**APPENDIX C - REVIEW OF THE CROOKWELL II WIND FARM EIS VISUAL ASSESSMENT
(JANUARY, 2005)**

Review of the Crookwell II Wind Farm EIS Visual Assessment

Summary Working Document

For
**The New South Wales Department of Infrastructure,
Planning and Natural Resources**

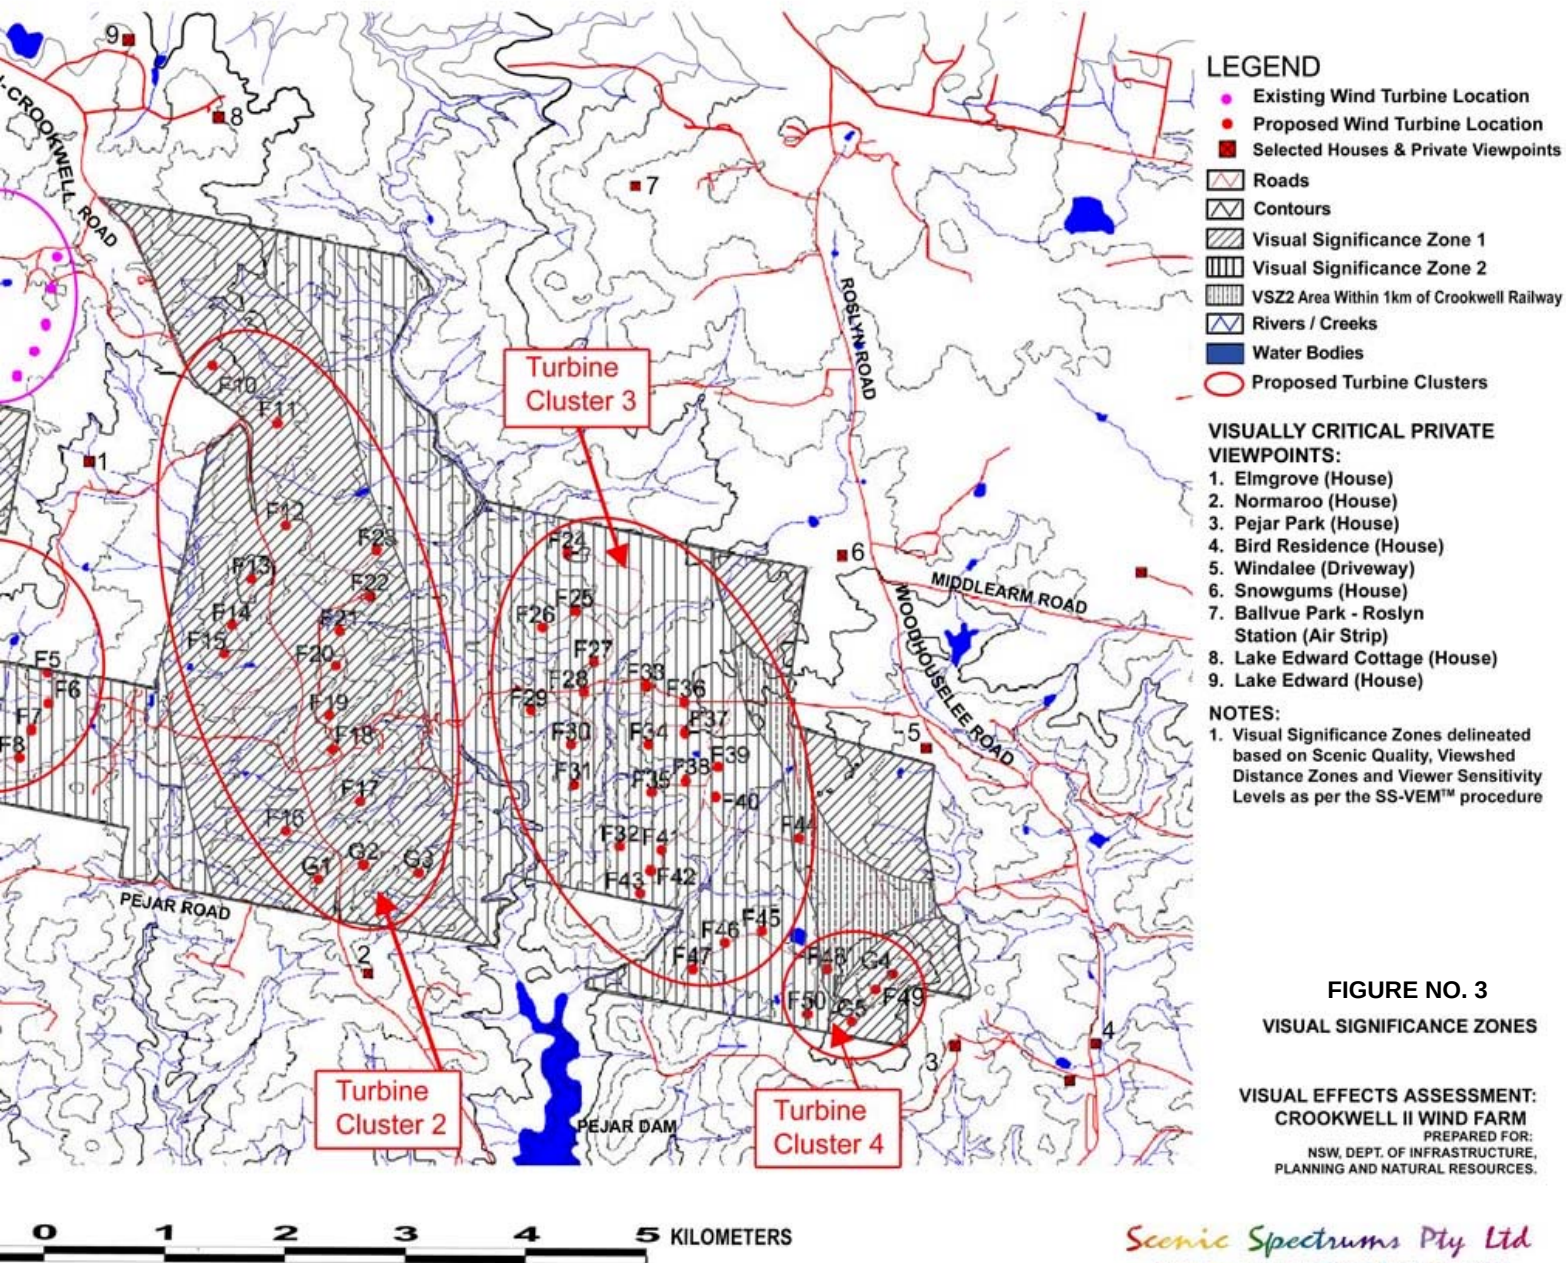
As is shown in Figure 4, the proposed turbines are primarily located on main or spur ridge sites above 845 m in elevation. Lateral spacing appears to vary greatly from approximately 180 m apart (G4 and F49) to approximately 630 m apart (F10 and F11). Distances between rows may be as much as 870 m (F4 to F6) to as little as 300 m (F32 and F41). Although some very specific wind behaviour dynamics may explain the layout and siting differences that occur, it is difficult to understand how such detailed wind modelling could be possible for an area of over 2000 hectares based on the data from only two or three wind turbines (as indicated in the EIS and through information provided by WFJV).

At this point, it is assumed that there is considerable scope for potential additional wind turbines within the proposed development site. Potential areas are mapped in Figure 4 for the purposes of illustration and for the development of the layout and siting options. We have identified areas on spur ridges at elevations above 845 m, away from stream gullies and beyond 1 km from existing houses where it appears that there would be room for additional turbines within the spacing tolerances displayed by the proposed turbine layout. In some areas, a minor reconfiguration of the proposed sites may be necessary to achieve a slightly higher density of turbines.

WFJV should examine these potential areas further in order to identify the viable additional sites. However, it certainly appears as if there is physically scope for many more wind turbines within the site. This would provide scope for the relocation of some proposed turbines from visually sensitive and vulnerable sites to those that are less sensitive.

Turbine Clusters 2 and 4 of the proposed development would not meet the recommended VSZ1 performance standards. With the exception of proposed Turbines F1, F2, F48 and F50, Turbine Clusters 1 and 3 would probably meet the recommended VSZ2 performance standards. As viewed from many public and private viewpoints, the proposed development would significantly change the existing landscape to a Wind Farm Pastoral character, reducing the existing scenic quality and resulting in a lower scenic integrity level than might be desired. With the exception of proposed Turbines F1, F2, F48 and F50, Turbine Clusters 1 and 3 would probably meet the recommended VSZ2 performance standards.

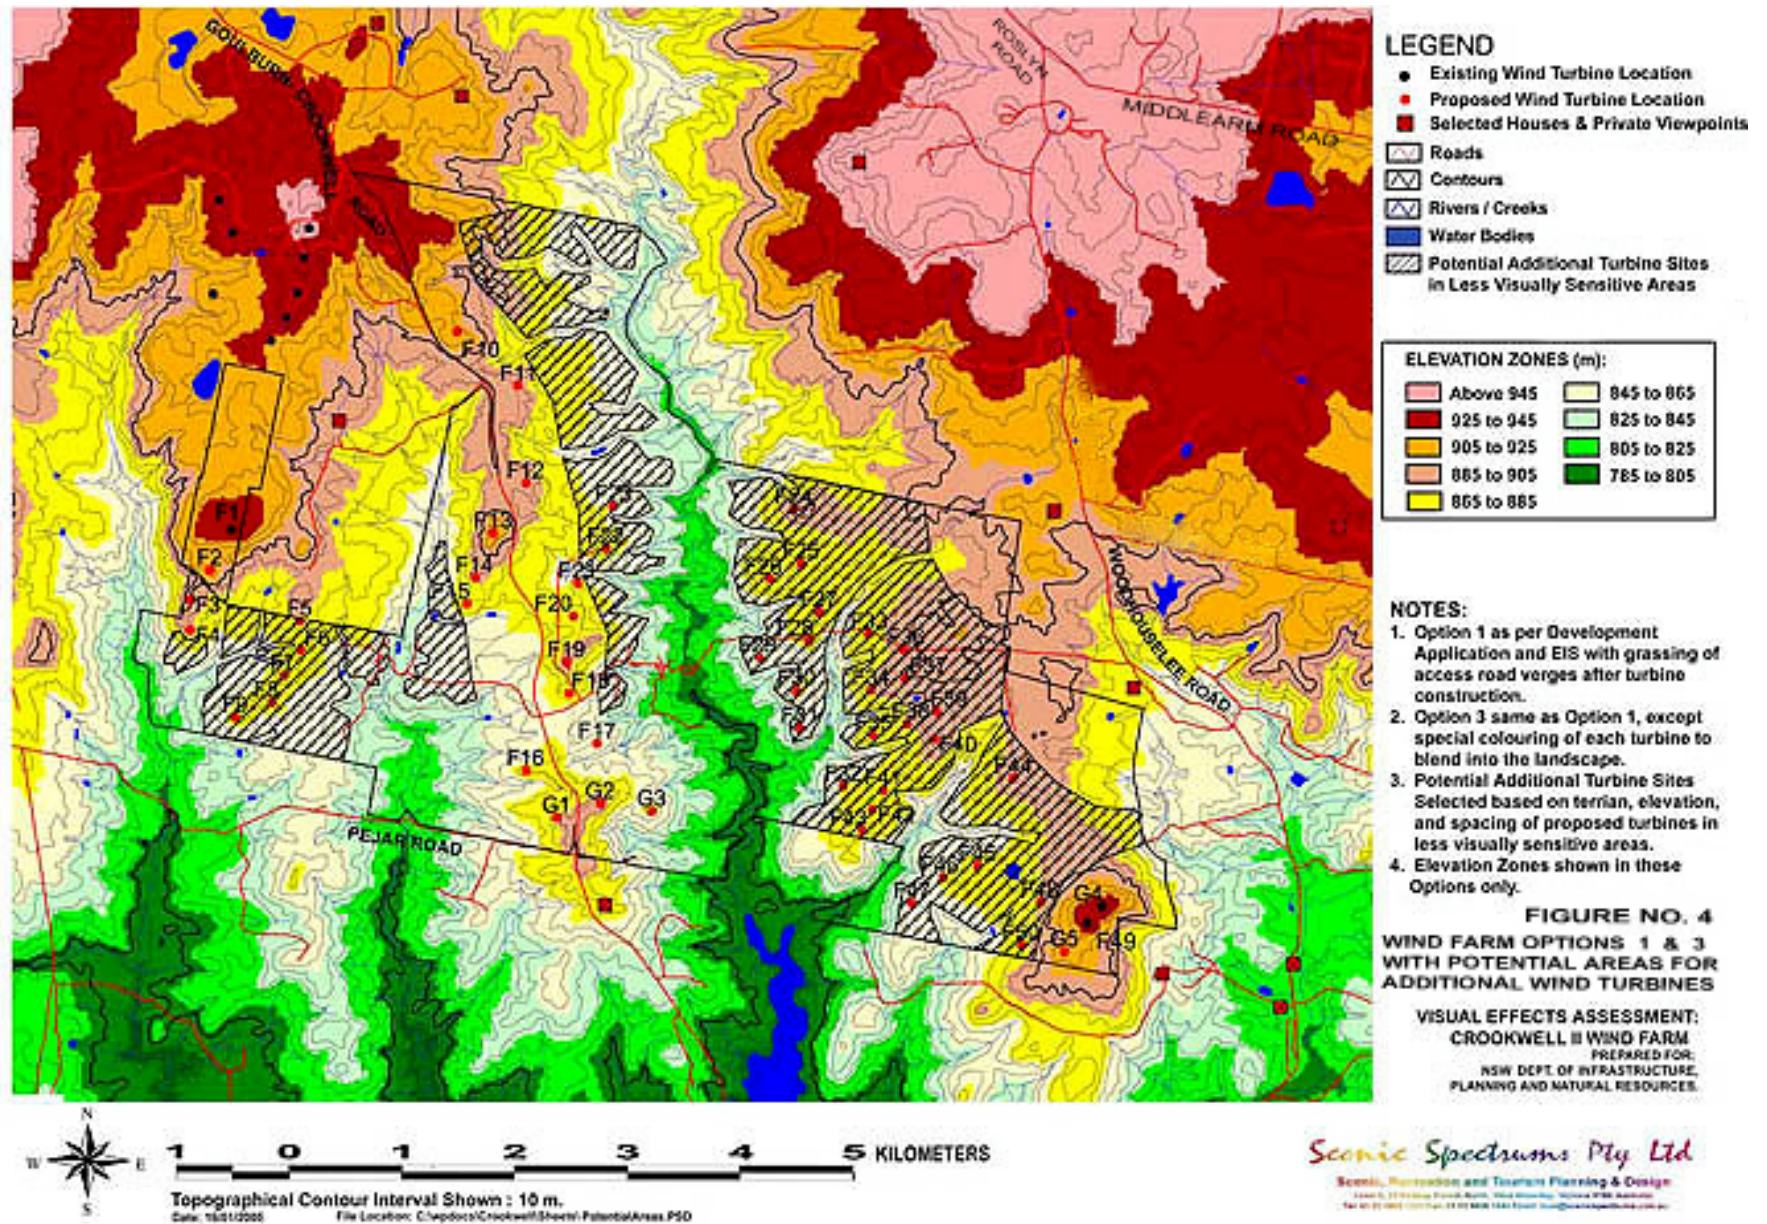
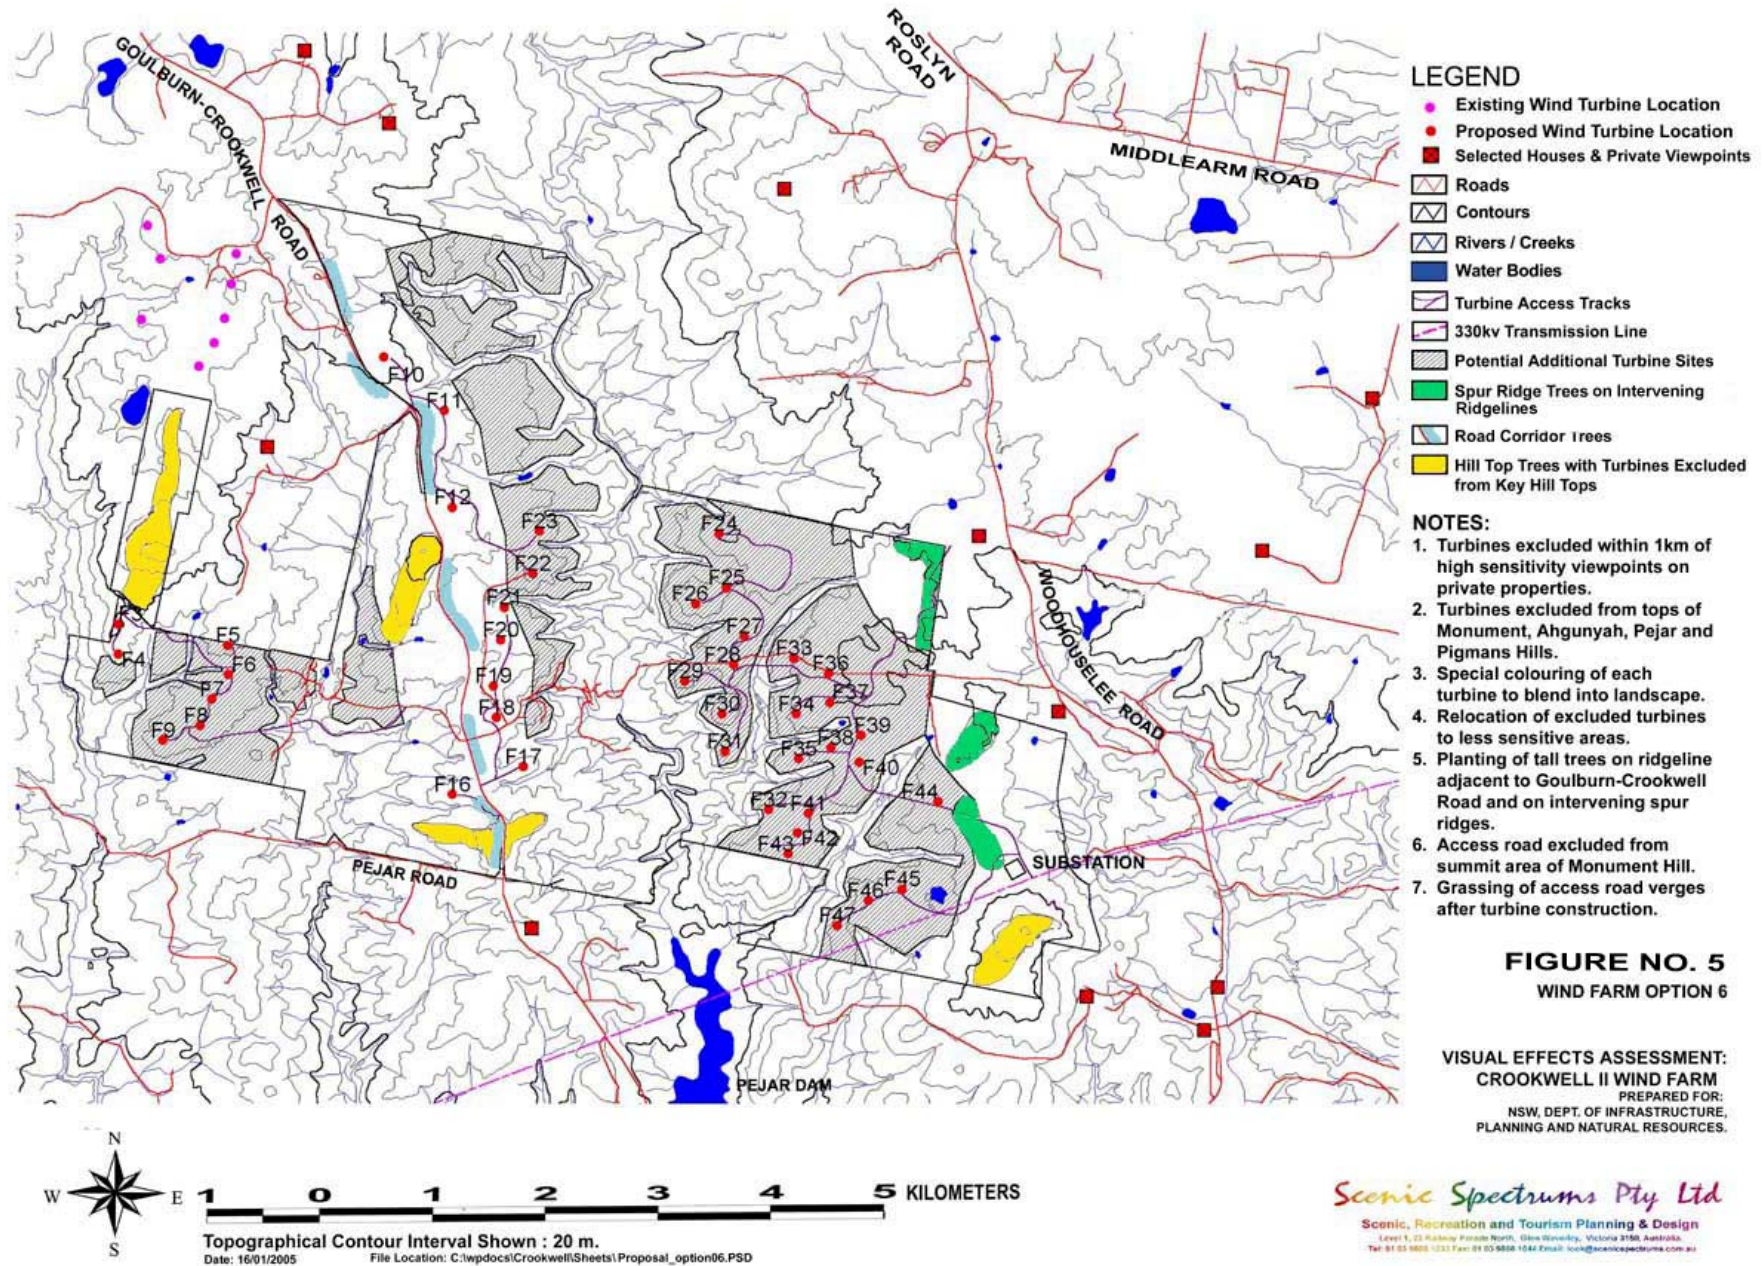
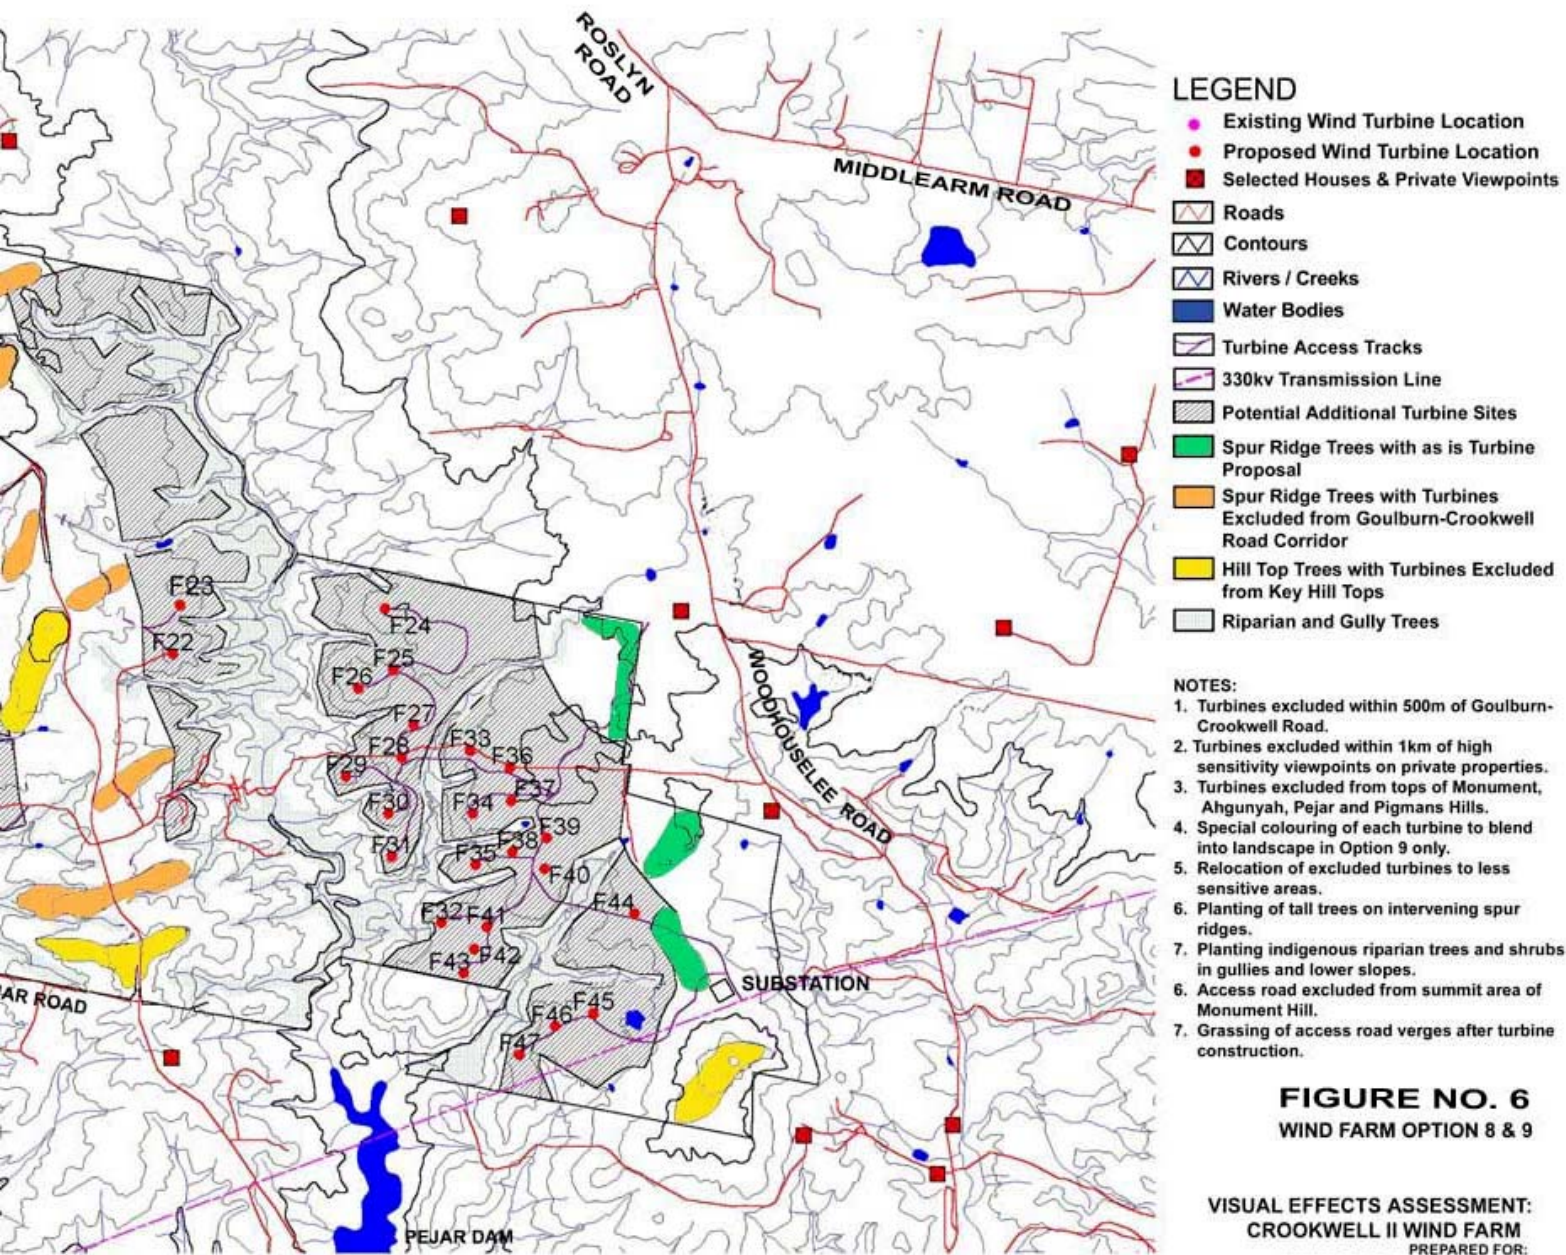
- Option 6 (refer to Table 11 and Figure 5)
- Option 8 (refer to Table 11 and Figure 6)
- Option 9 (refer to Table 11 and Figure 6).

Option 6 would allow the proposed wind farm under the following conditions:

- exclude or relocate turbines from within 1 km of high sensitivity residences
- exclude or relocate of turbines from local landmarks and focal points
- special individual colouring of wind turbines to reduce their visual contrast and impact, allowing them to better blend into the landscape
- provision of tree plantings along the Goulburn-Crookwell Road and on intervening spur ridges to effectively screen the turbines and direct motorists and residents visual attention away from the turbines as much as possible.

The greatest visual drawback of Option 6 would be the continuation of many turbines within a relatively short distance of the Goulburn-Crookwell Road given local concerns for the views from this section of road.

Option 8 would allow the proposed wind farm under the following conditions:

- exclude or relocate turbines to areas outside a 500 m setback from Goulburn-Crookwell Road
- exclude or relocate turbines from within 1 km of high sensitivity residences
- exclude or relocate turbines from local landmarks and focal points
- provision of the planting of intervening ridges, gullies and the Wollondilly River Valley to achieve effective vegetative screening and scenic enhancement.

The major visual drawback of Option 8 is the lack of colouring of turbine towers and blades to better blend in with the landscape.

Option 9 is Scenic Spectrums' most preferred option. It would allow the proposed wind farm under the following conditions:

- exclude or relocate turbines to areas outside a 500 m setback from Goulburn-Crookwell Road
- special individual colouring of wind turbines to reduce their visual contrast and impact, allowing them to better blend into the landscape
- exclude or relocate turbines from within 1 km of high sensitivity residences
- exclude or relocate turbines from local landmarks and focal points
- planting of intervening ridges, gullies and the Wollondilly River Valley to achieve effective vegetative screening and scenic enhancement.

Option 9 is preferred from a visual standpoint because it would most effectively minimise the potentially significant adverse visual effects of the wind farm while allowing the development to become established in a more harmonious with the scenic values and concerns of the local community.
